Preliminary Acceptance Punchlist
El Paso County – Department of Public Works - Stormwater Section

Project Name:	Struthers Ranch Polaris
EDARP Filing Number(s):	PPR2248, CON2319
ESQCP Number:	ESQ2315
Attendees:	DPW SW: Shannon Mustoe, Benjamin Jones DPW Development Services: Spencer Pirzadeh Developer: Contractor was present (Todd Jeffers and one other)
Date of Walk-through:	06/17/2024
Walk-through Number:	1 st

Water Quality Pond A (Sheet C3.1):

Photo 3: Trickle Channel: Appears to be about 1" in depth. Plans call for 6". Fill in pond bottom to match top of trickle channel.

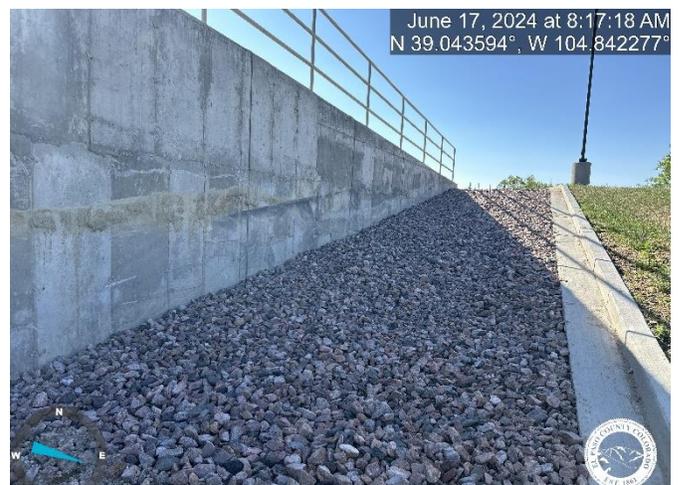
- Trickle Channel: Appears to be about 1” in depth. Plans call for 6”. Install per approved plans or confirm with your project engineer that this change from the plans is acceptable and then reflect the change on the as-builts. Reference Photo 3.

- Pond Bottom
 - Pond bottom below grade of trickle channel curb. Fill to match top of trickle channel. Reference Photo 3.
- An approved "PCM Maintenance Agreement" (formerly the "Private Detention Basin / Stormwater Quality Best Management Practice Maintenance Agreement and Easement") has not yet been signed by the responsible party and uploaded to EDARP. Please work with EPC Stormwater Staff to resolve.
